**ADDENDUM NO. 5
TO
CONTRACT DOCUMENTS, SPECIFICATIONS AND PLANS
FOR IMPROVEMENTS TO THE
ST. JOSEPH ROSECRANS MEMORIAL AIRPORT
ST. JOSEPH, MISSOURI
MODOT PROJECT NO. 22-012A-1**

To All Bidders: You are requested to make all changes and/or additions contained in this addendum to the Bidding Documents. Failure to acknowledge this Addendum in Proposal shall result in rejection of bid. Bidders are informed that the above referenced Questions with Corresponding Answers, Contract Documents, Specifications, and Plans are modified as follows as of December 7, 2022.

A-711

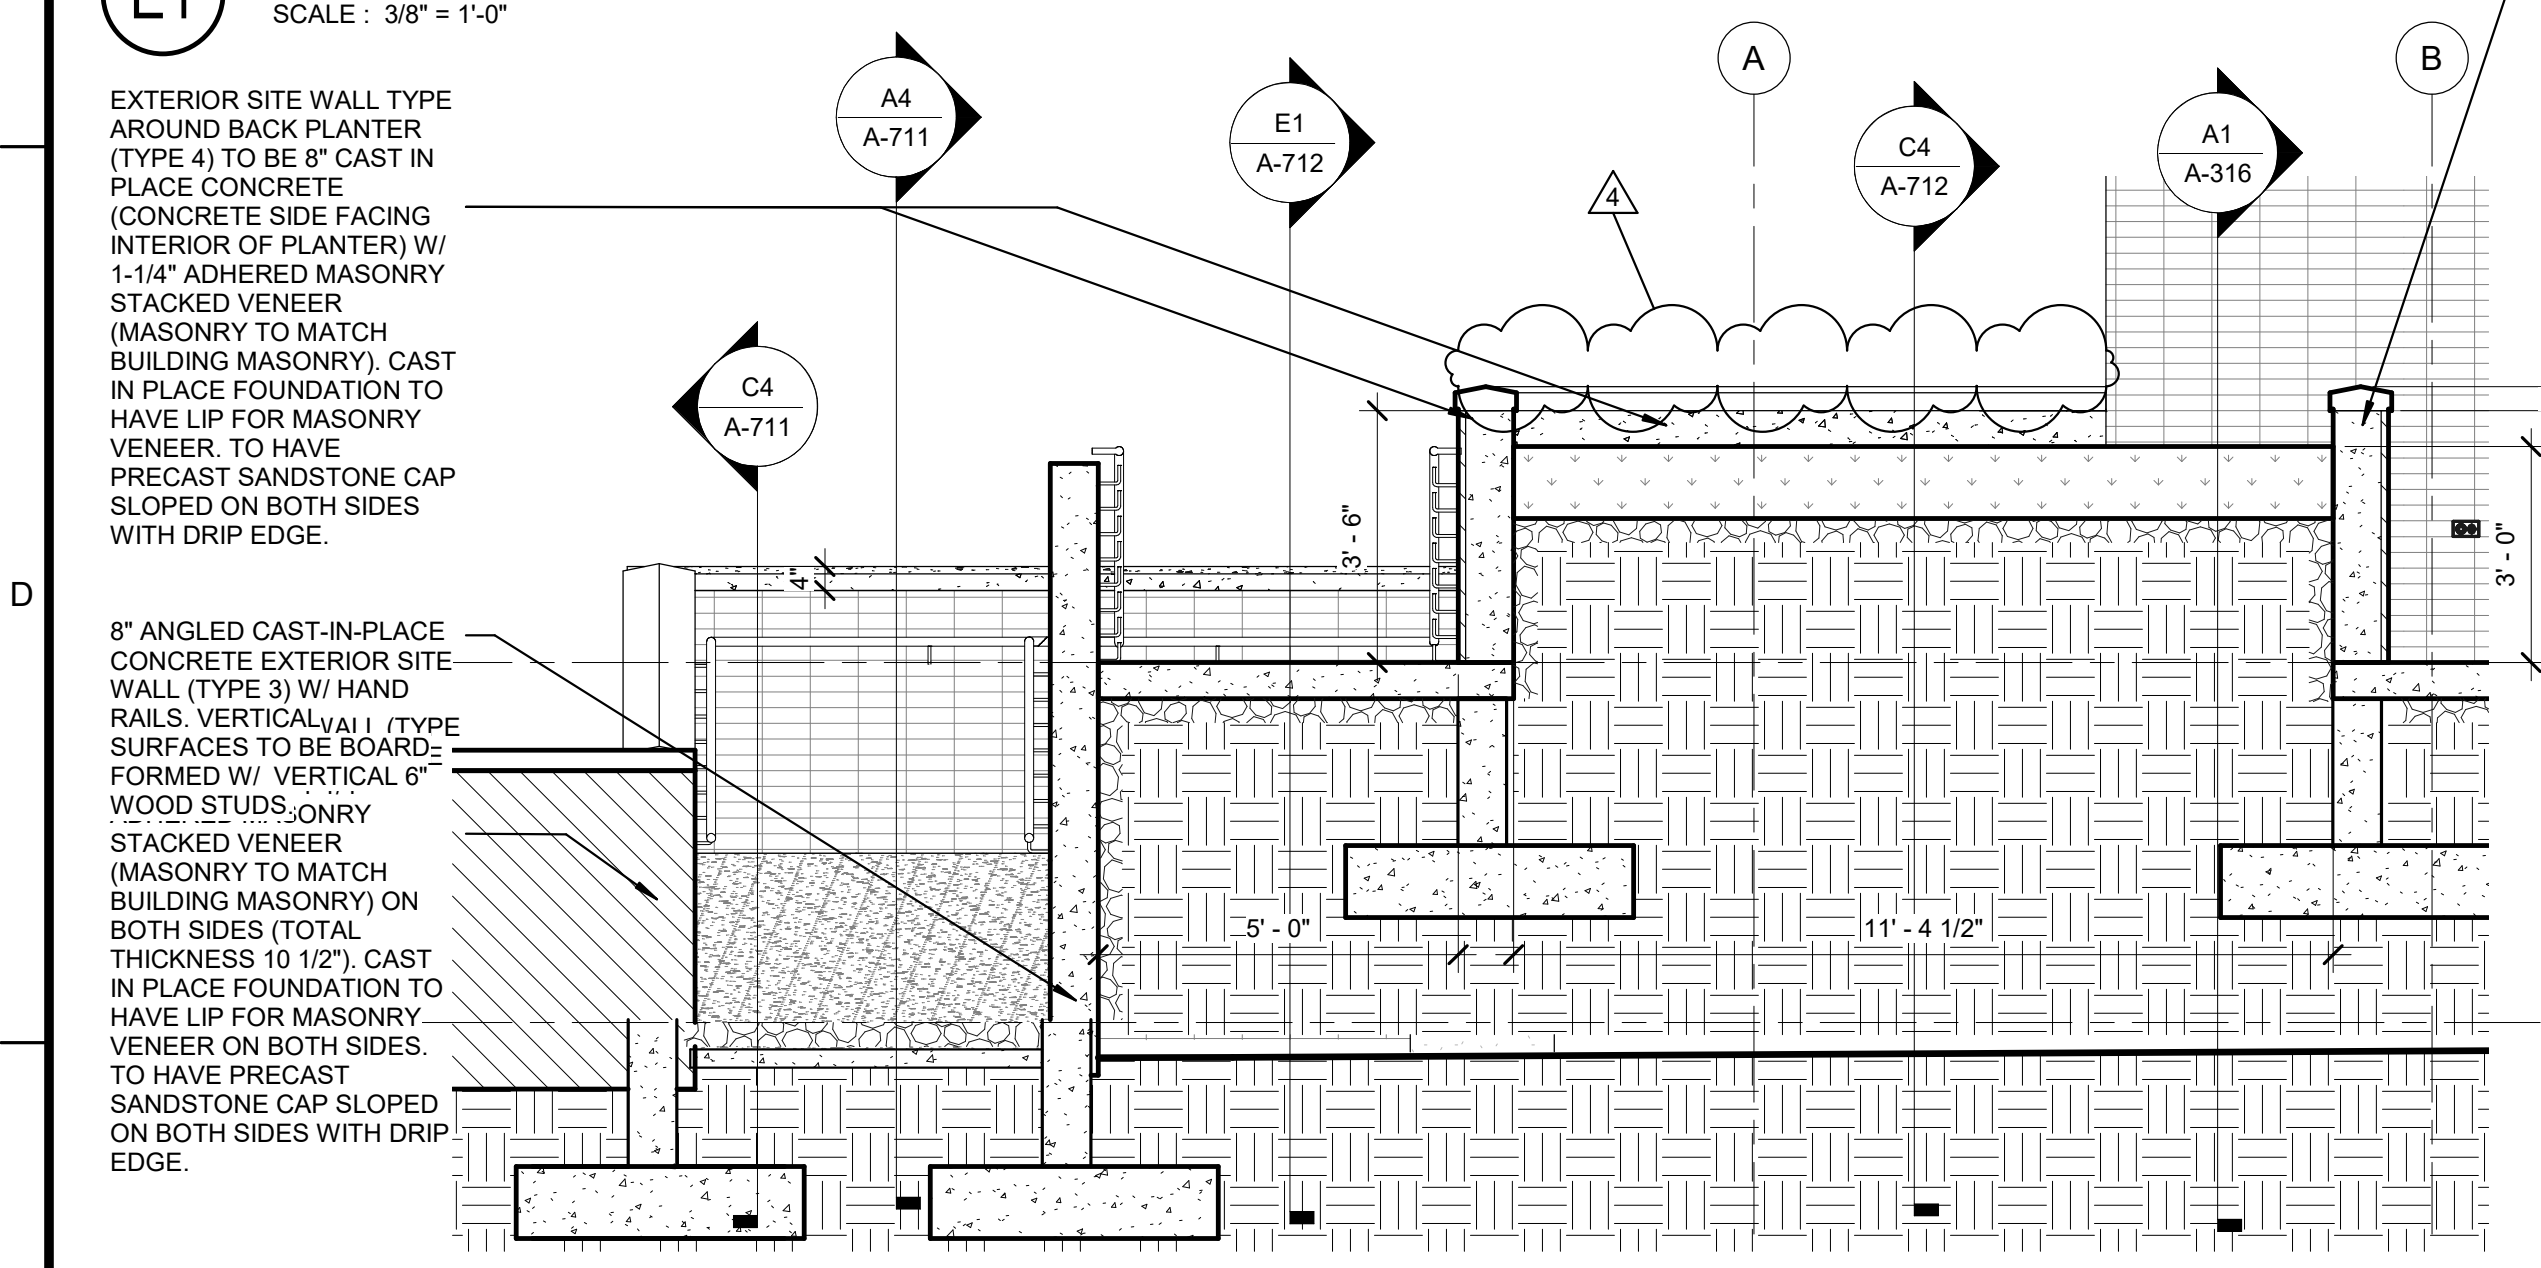
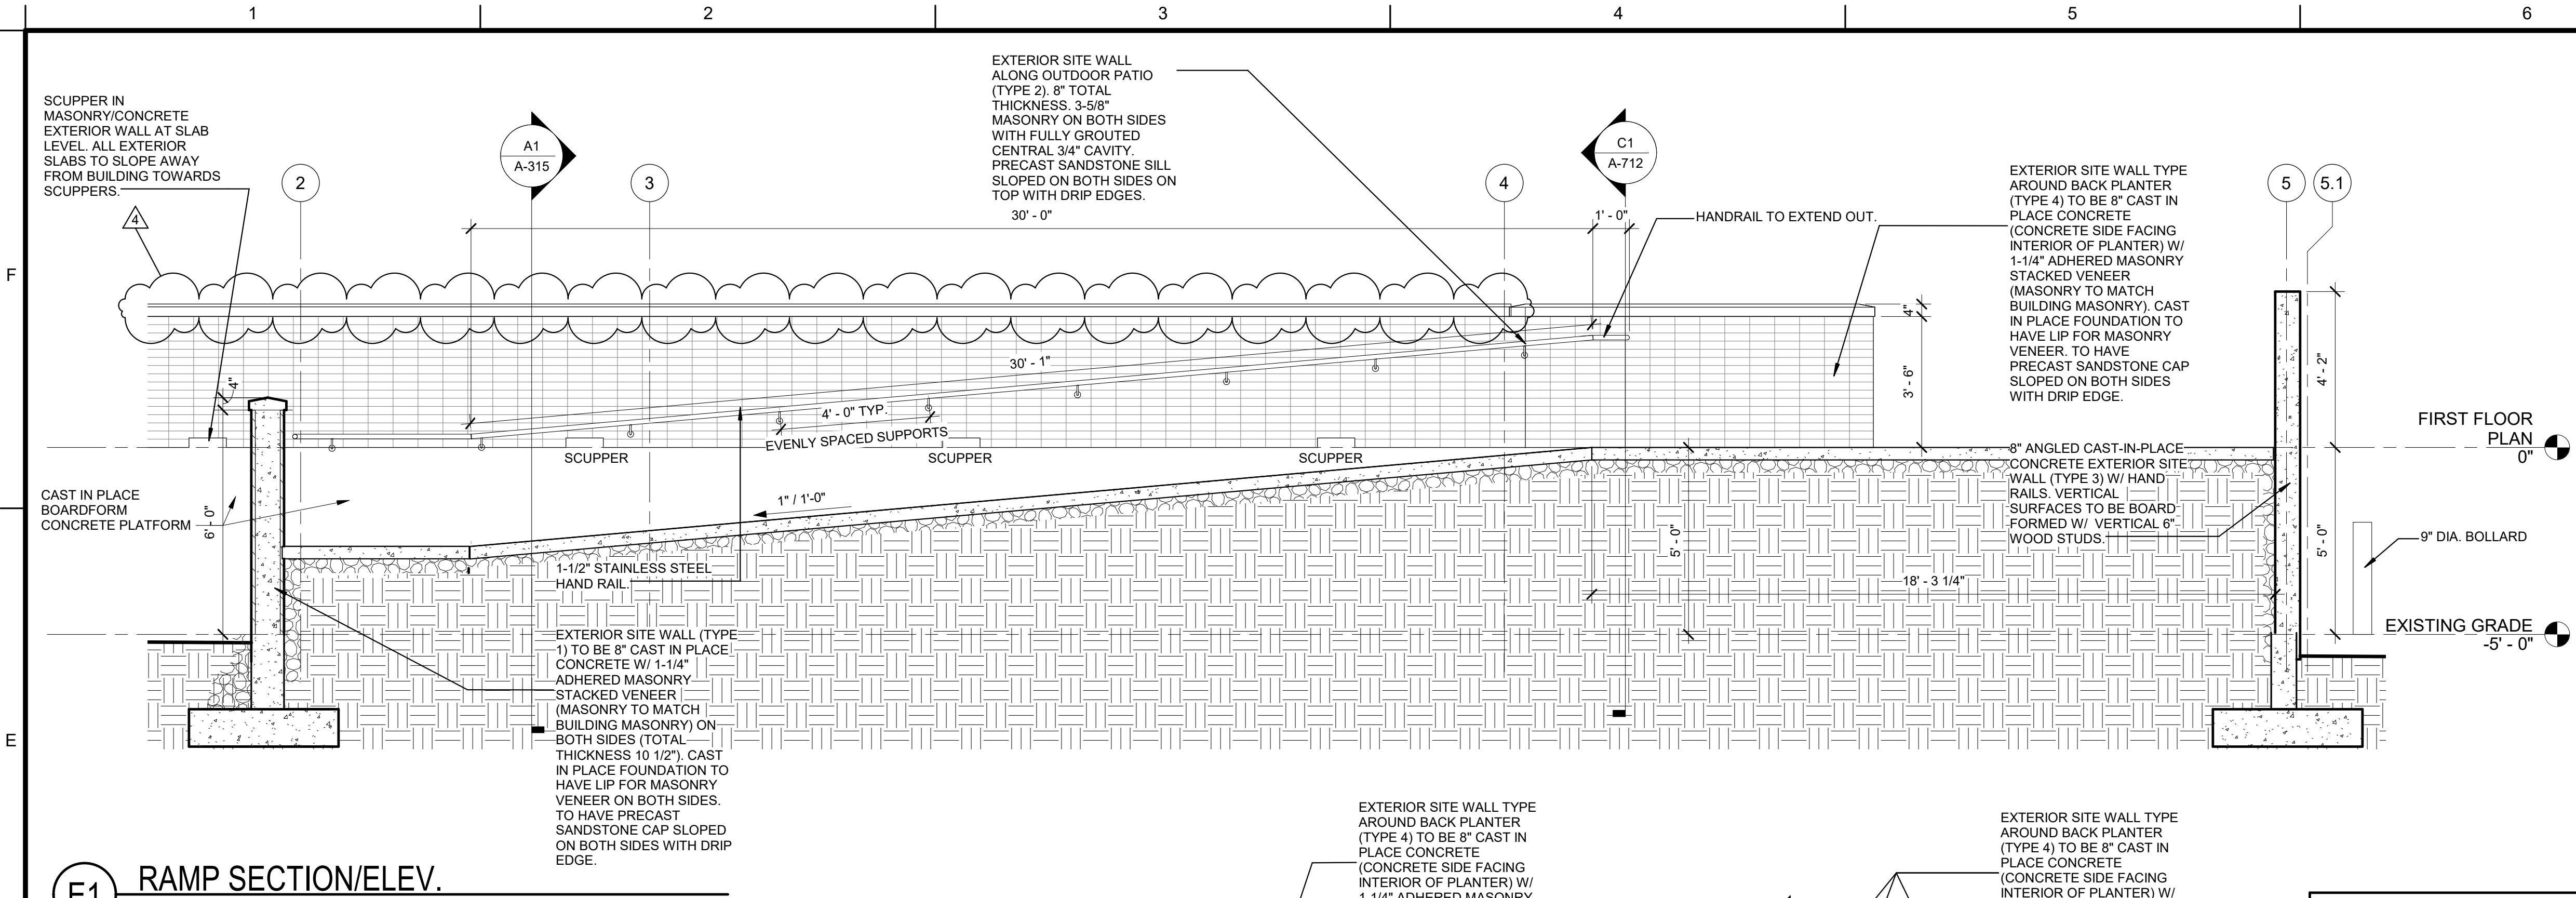
Sheet A-101, A-102, A-202, A-301, A-315, A-711, A-712

Revision: Removed glass half wall along outside patio.

4. With the tempered laminated glass half wall along the outside patio being set into a reglet in the stone, could moisture accumulation at the base of the glass eventually degrade the PVB inner layer causing an appearance problem?
 - a) The half glass partition along the patio wall has been removed entirely. This can be seen in revised plans A-101, A-102, A-202, A-301, A-315, A-711, and A-712
